Access Compliance Report

Public Rights-of-Way

Intersection ID: 54219	Main Street: SANDY_ROCK_PL	Cross Street: NORTH_REA_PARK_LN	Location: NE
ADA ID: F3133362AFBC	Ramp Type: Perp	Initial Pass/Fail: Pass	Overall Compliance: No
		Severity Score: 5

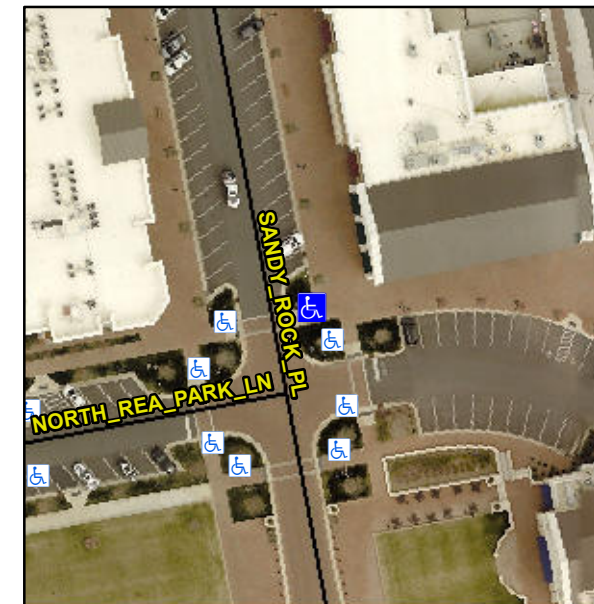
**Remove & Replace Entire Ramp.
Remove & Replace Gutter.**

**Not Found, R304.2.2-Perp, R304.3.2-
Para, R304.5.4**
